Proposed Corriegarth 2 Wind Farm: Response to SEPA Consultation Request

Appendix A – Amended Figures

Corriegarth 2 Wind Farm

Ref: 3369-REP-099

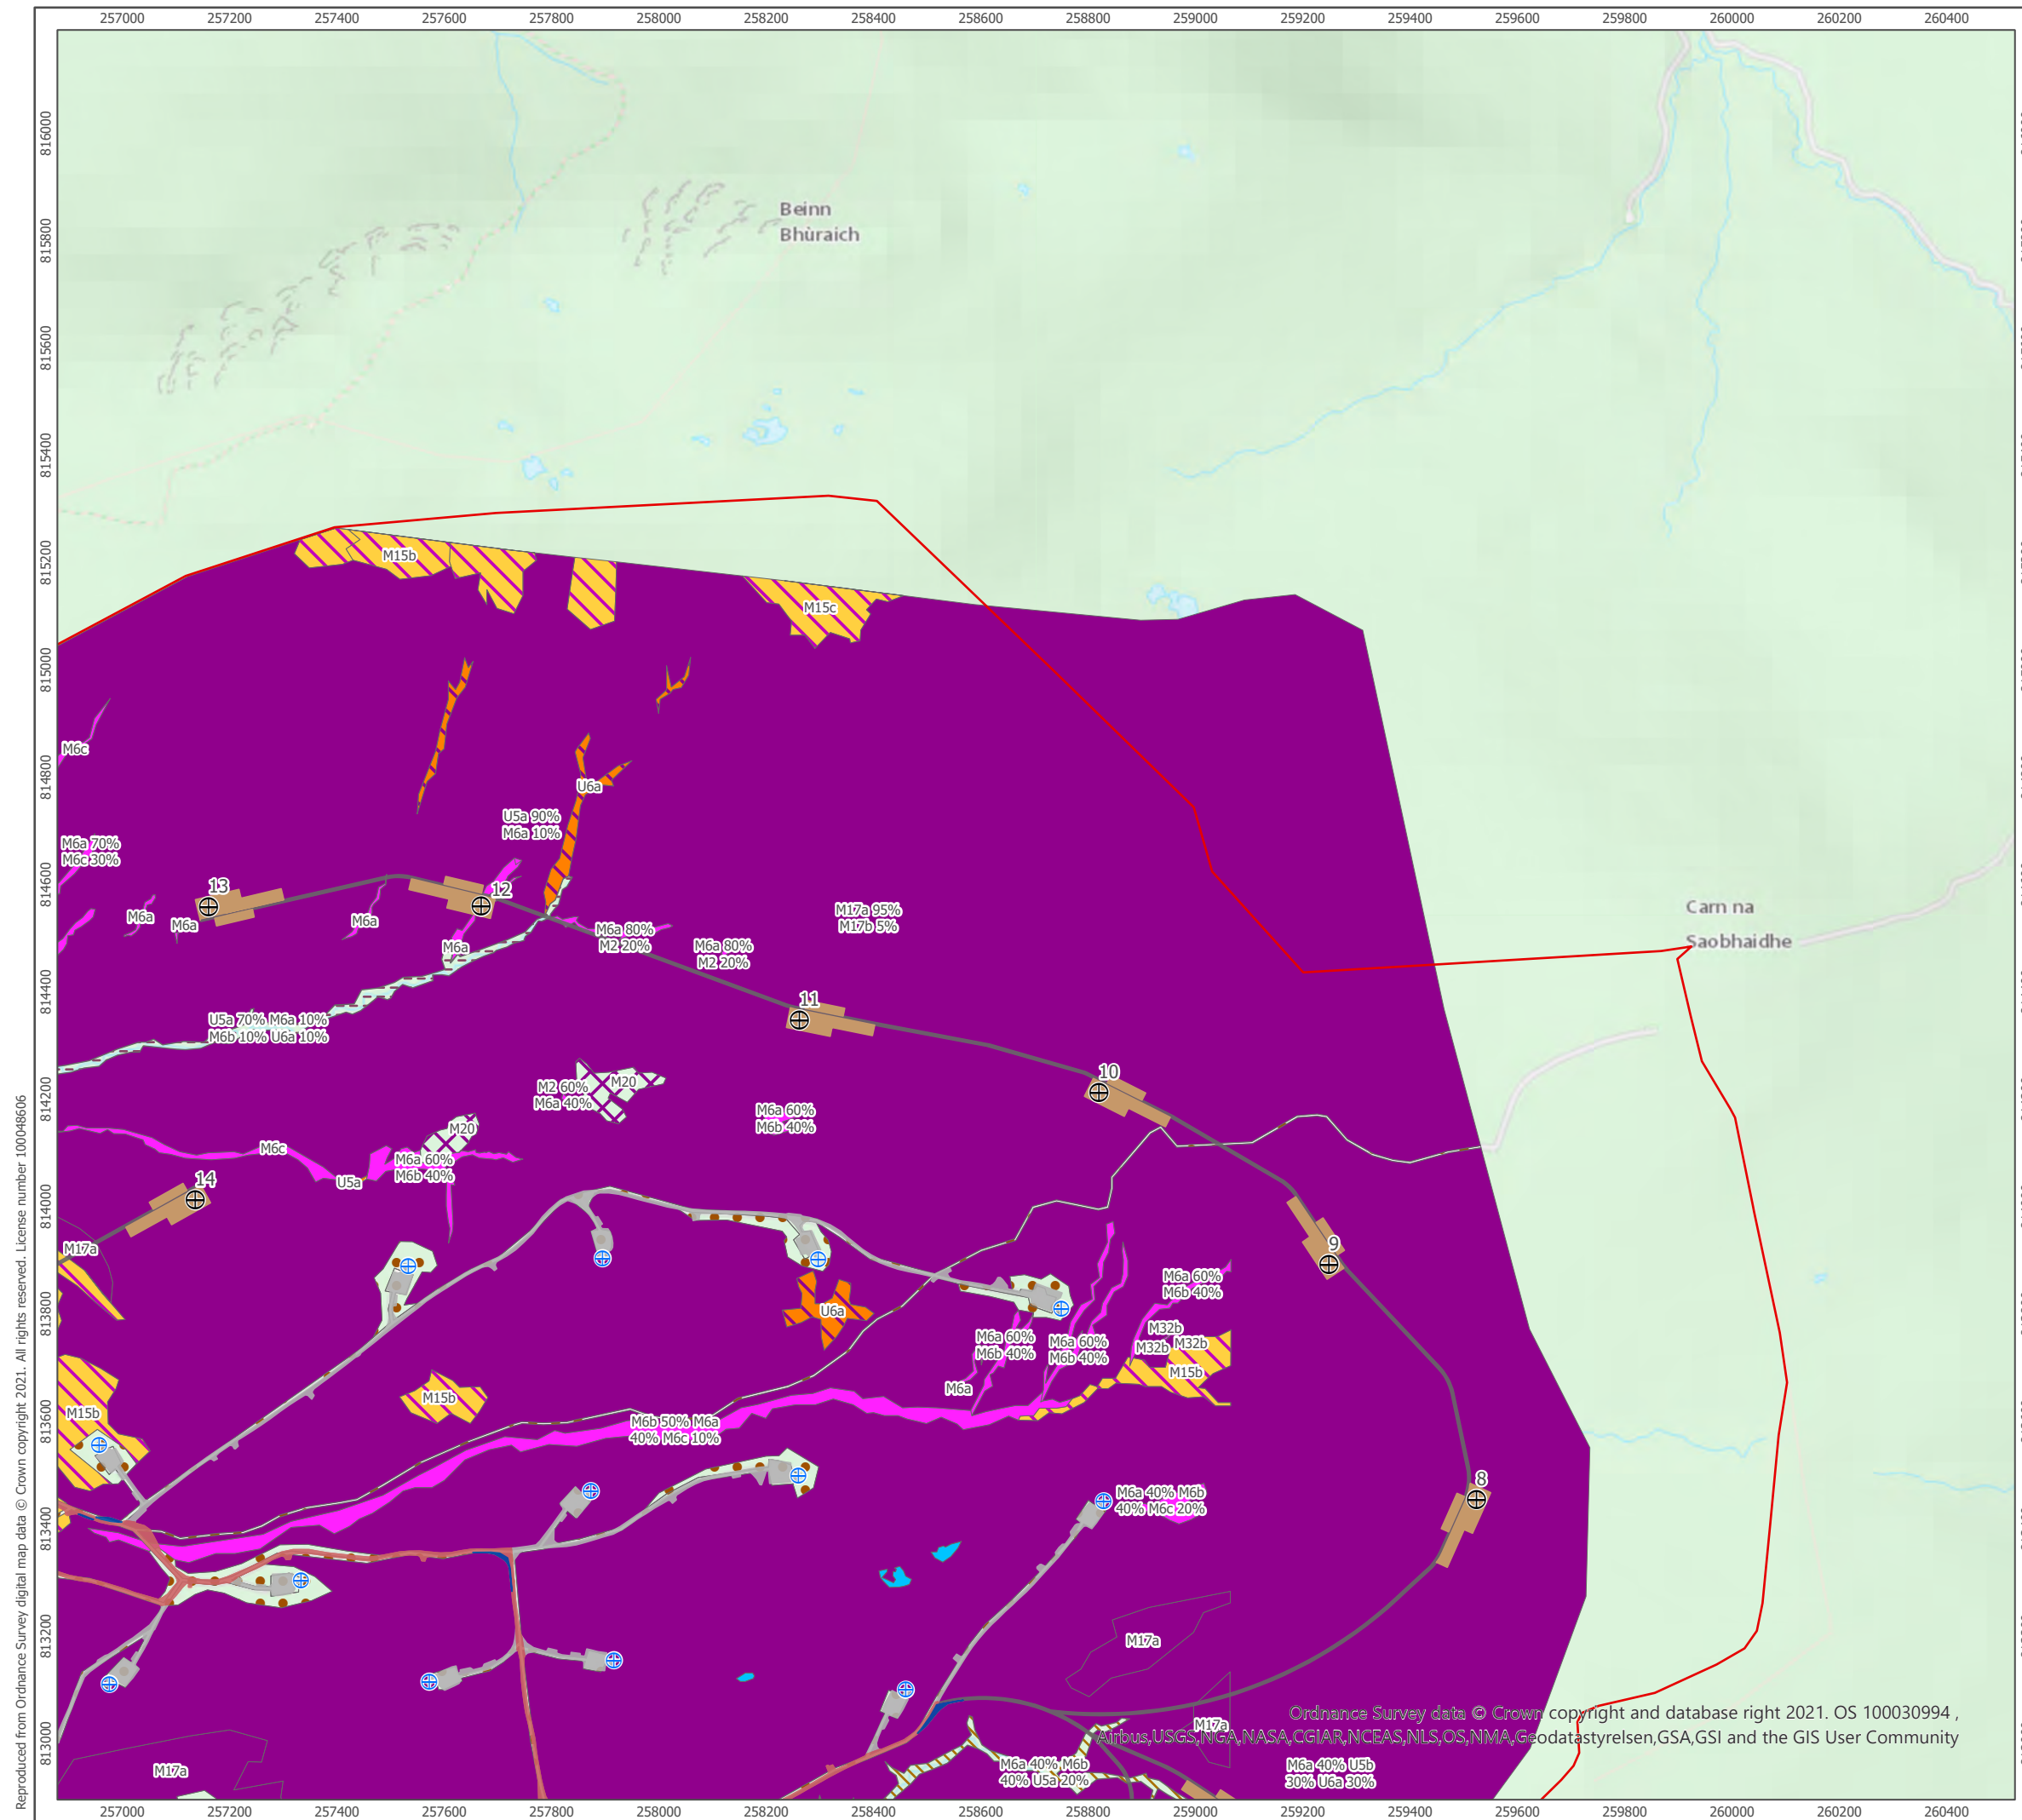
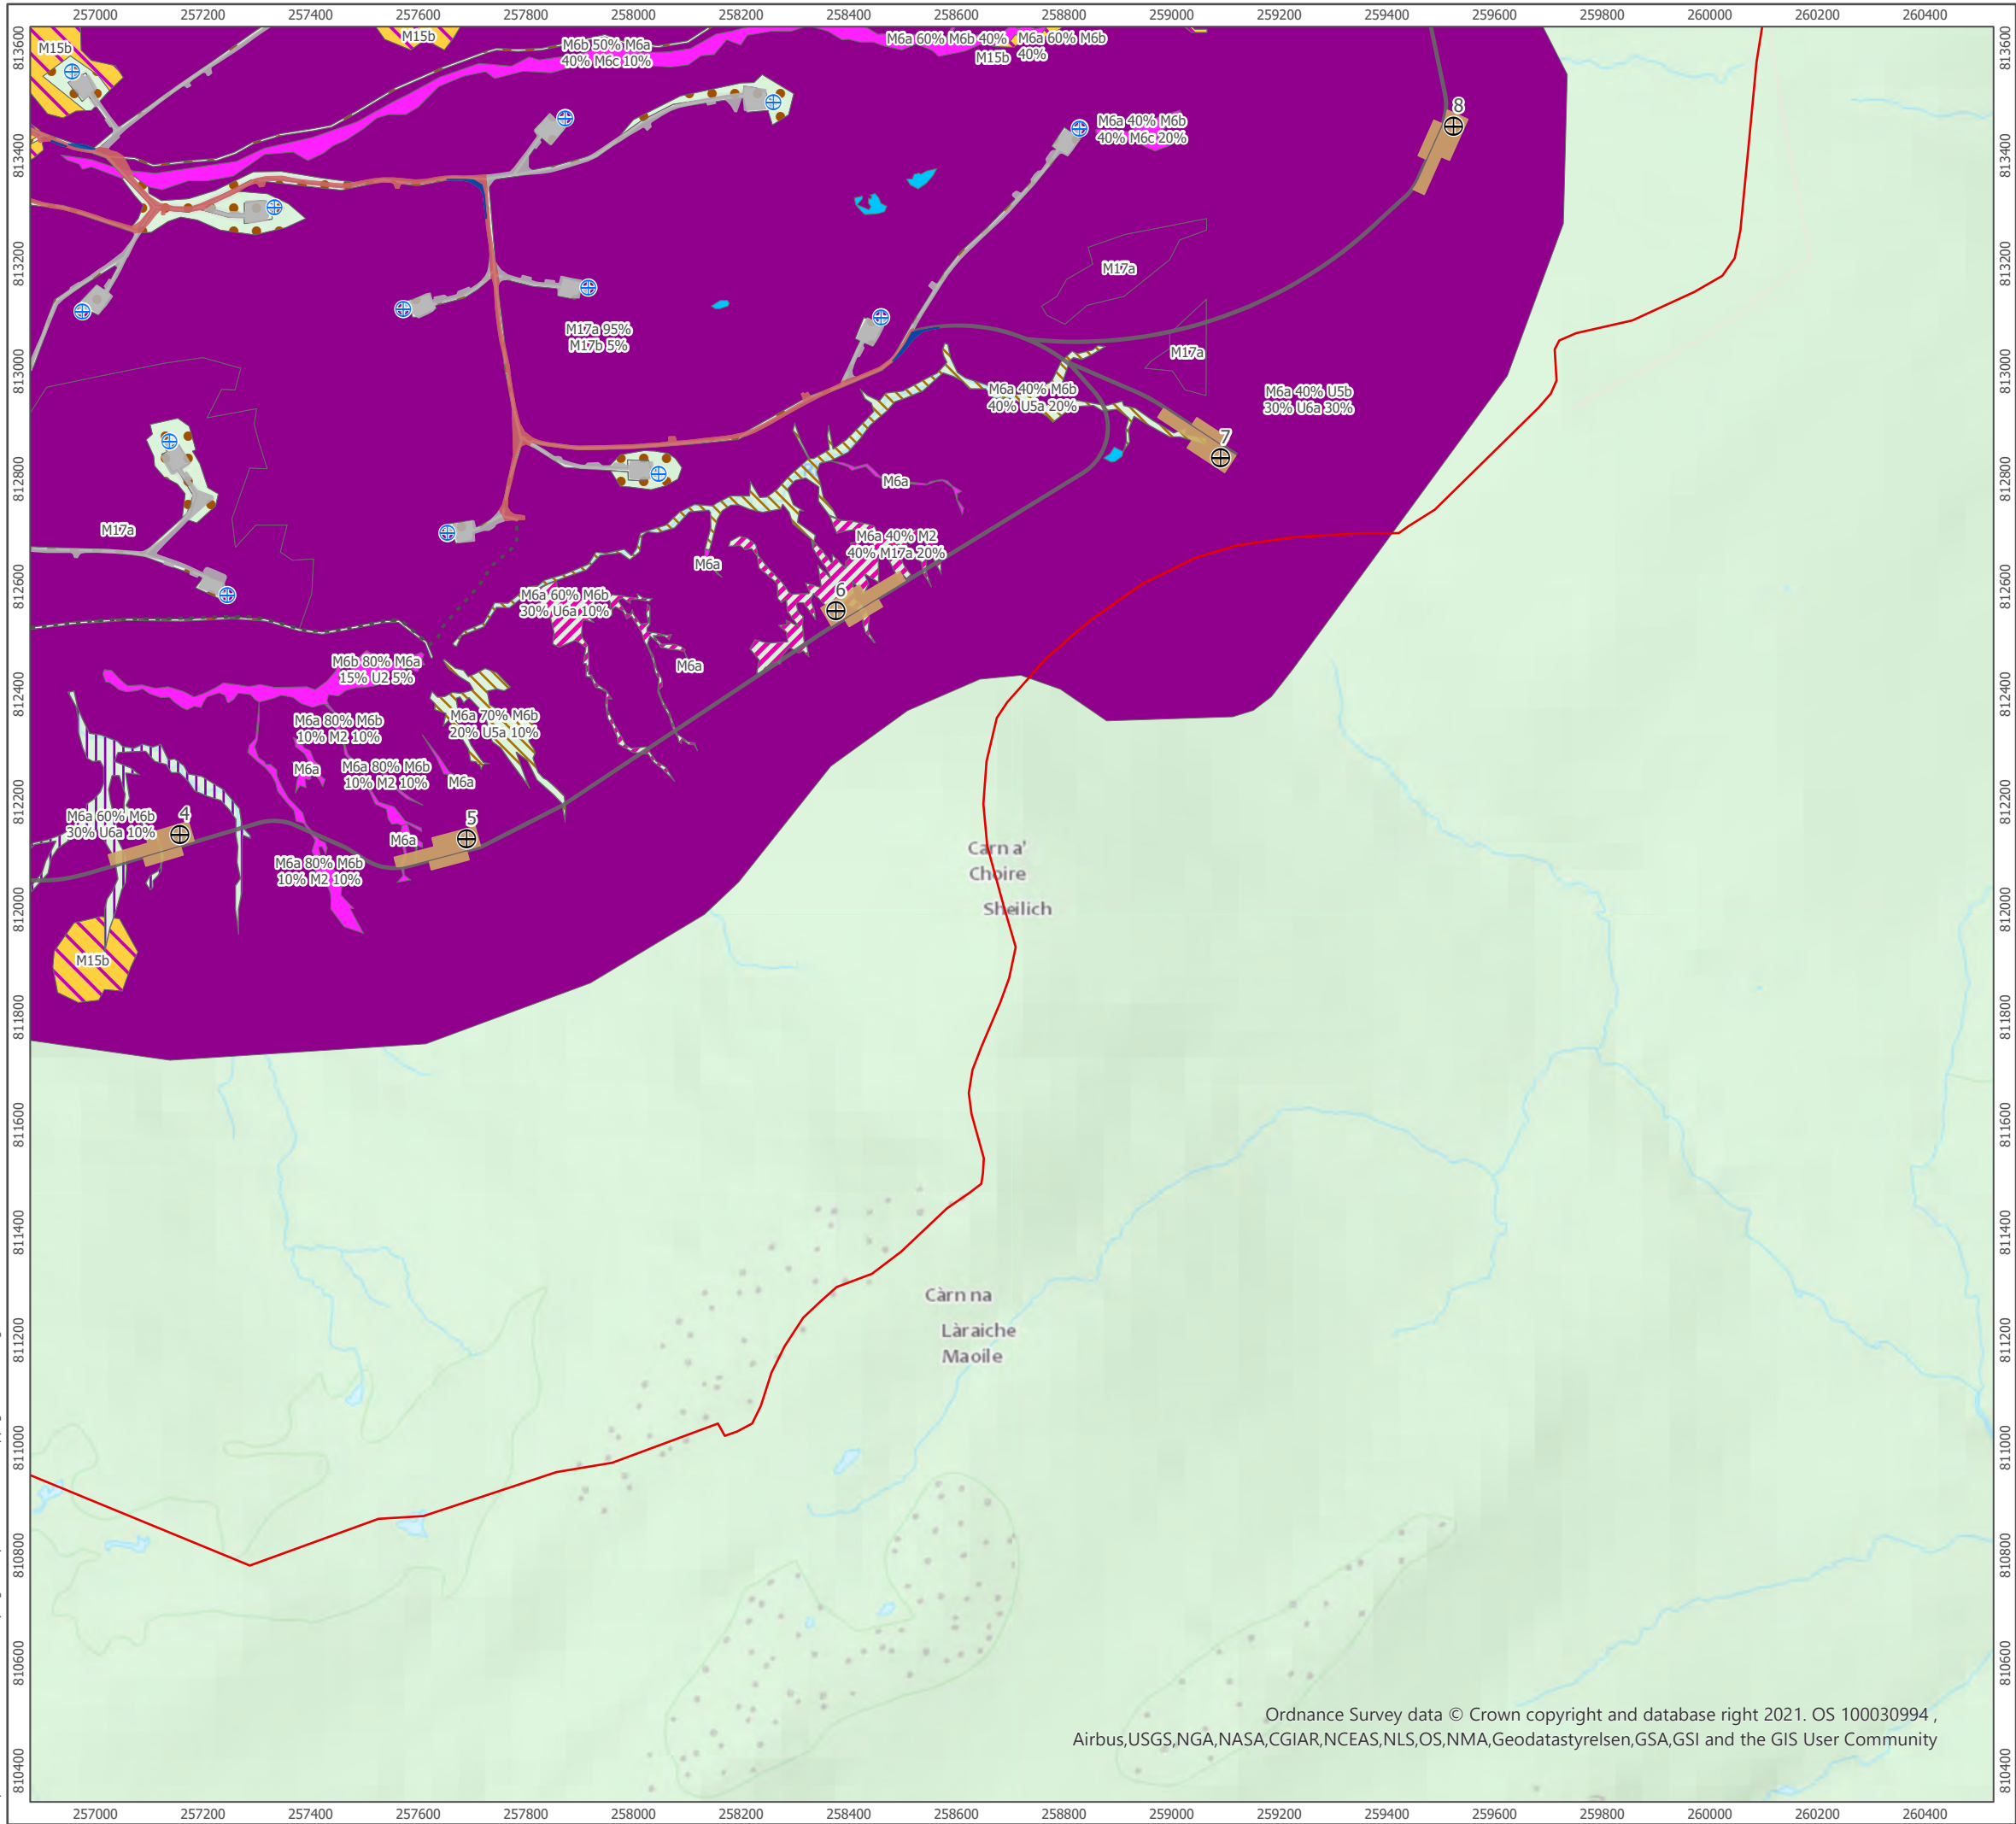
1. Figure 7.2 of Chapter 7: Ecology of the EIA Report is amended to include all proposed infrastructure associated with the Development (clearly marked);
2. All of the figures contained within Technical Appendix A7.1: Habitats and Botany Surveys to include all proposed infrastructure associated with the Development (clearly marked); and
3. Figure 13.2.2 of Technical Appendix A13.2: Outline Peat Management Plan to be provided on OS Basemapping; to be provided in a map series format; and with a revised symbology colour ramp.

SEPA Amendment Request¹	Applicant Response
1.	Arcus Consultancy Services Ltd ('Arcus'), on behalf of Corriegarth 2 Wind Farm Limited ('the Applicant'), have added all proposed new infrastructure associated with the Development to Figure 7.2. The added infrastructure associated with the Development is clearly marked via the legend. Due to the number of entries in the legend, the text and indicative symbol boxes have had to be reduced; however, it is considered that all information remains clear. Figure 7.2 also includes the NVC labels, as requested by SEPA through further discussion with Arcus (via telephone 06/07/2021). Figure 7.2 now also includes an overview figure for ease.
